GROUP A GENERAL WG – OCTOBER 2-3, 2018

PUBLIC COMMENTS

G151-18

Public Comment 1:

3114.8.5.3(1)
Bracing Unit Distribution--Maximum Linear Length

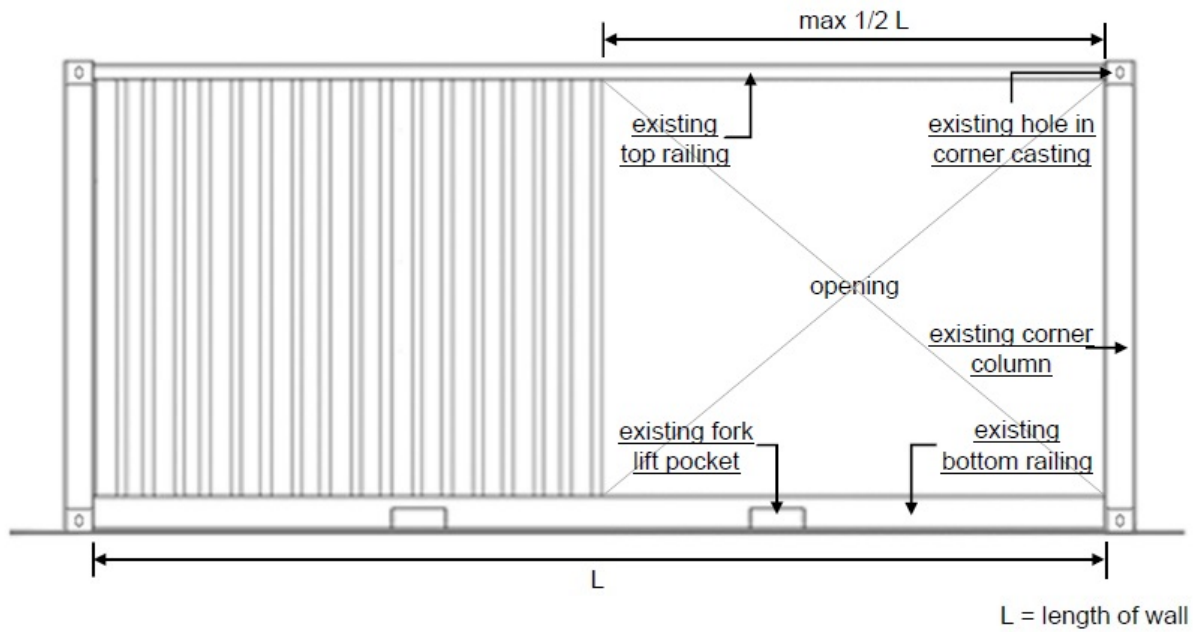
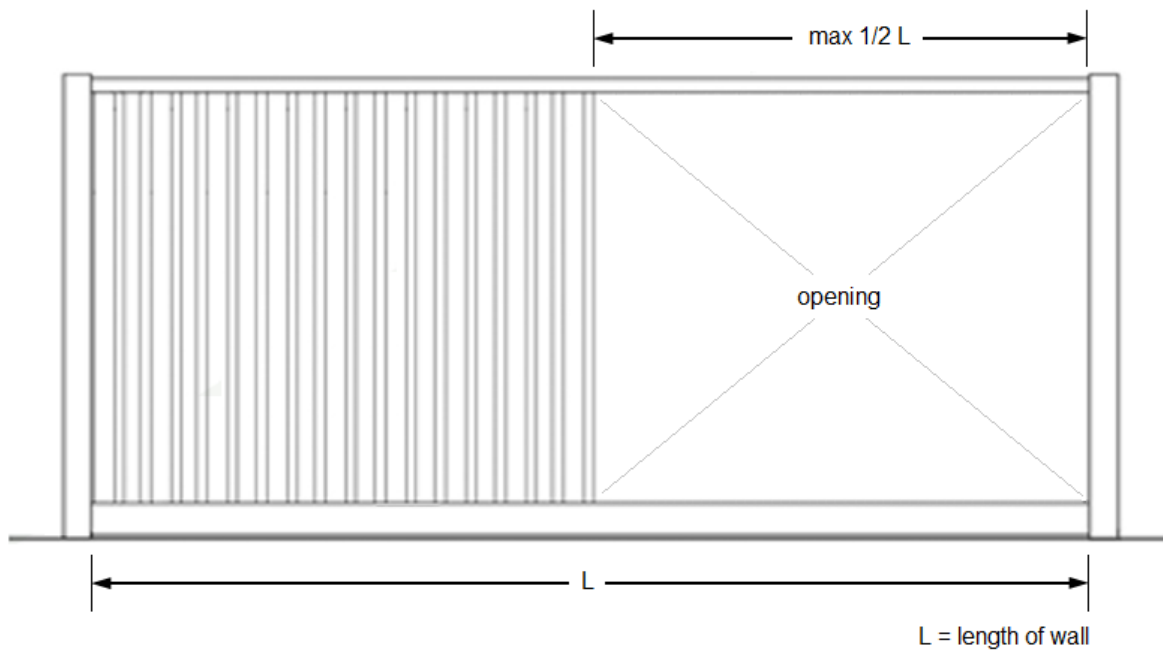
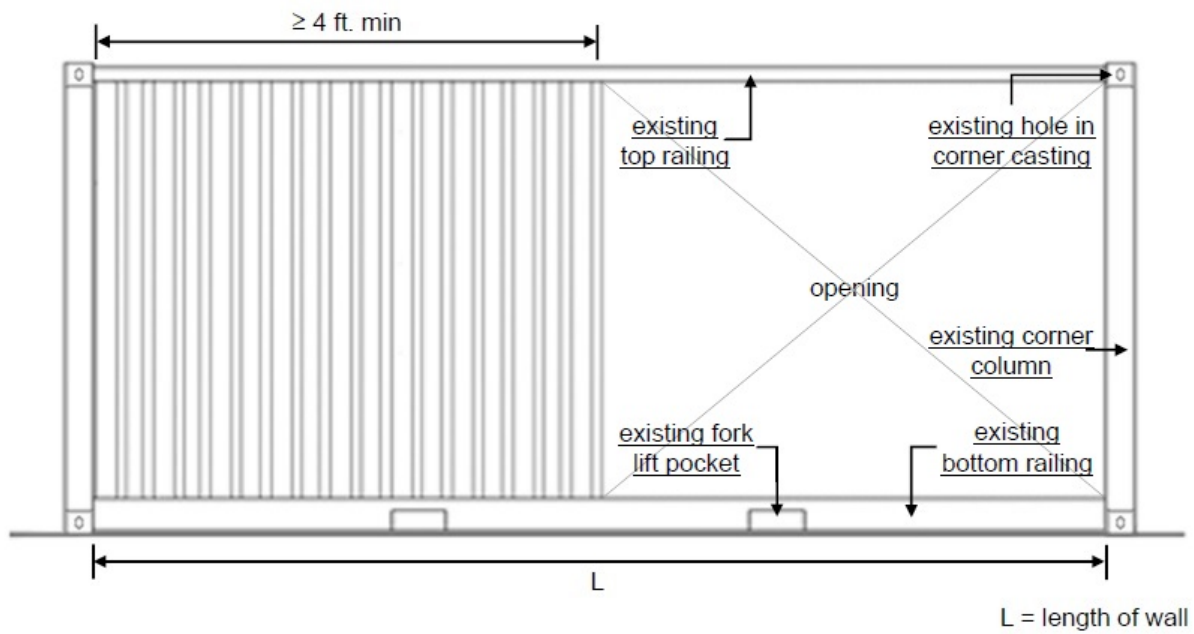
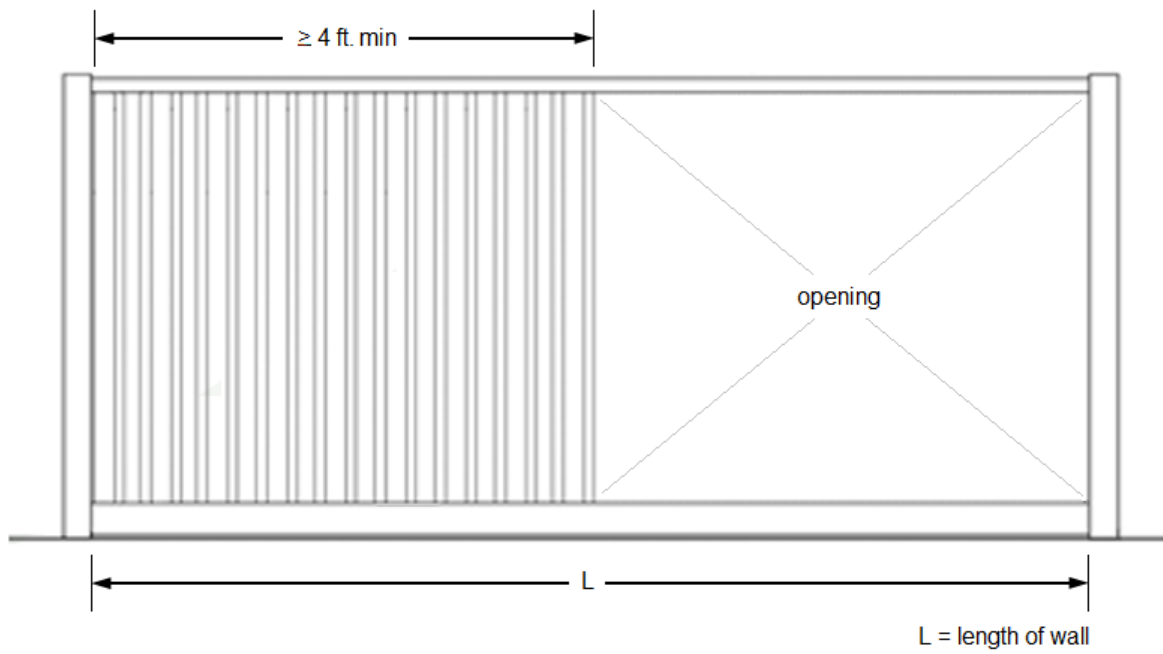
Figures 3114.8.5.3 (1) through (4) - It was brought to our attention that it may be beneficial to identify parts of the intermodal shipping container more clearly rather than use a simple line drawing figure. This is for the benefit of the user to more readily recognize existing conditions versus the permissible cut-aways as allowed by Section 3114.8.5.3. In

response we are proposing to add identifying text (the rails, lift slots, and holes) to illustrate those existing elements that are part of the manufacture of intermodal shipping containers.
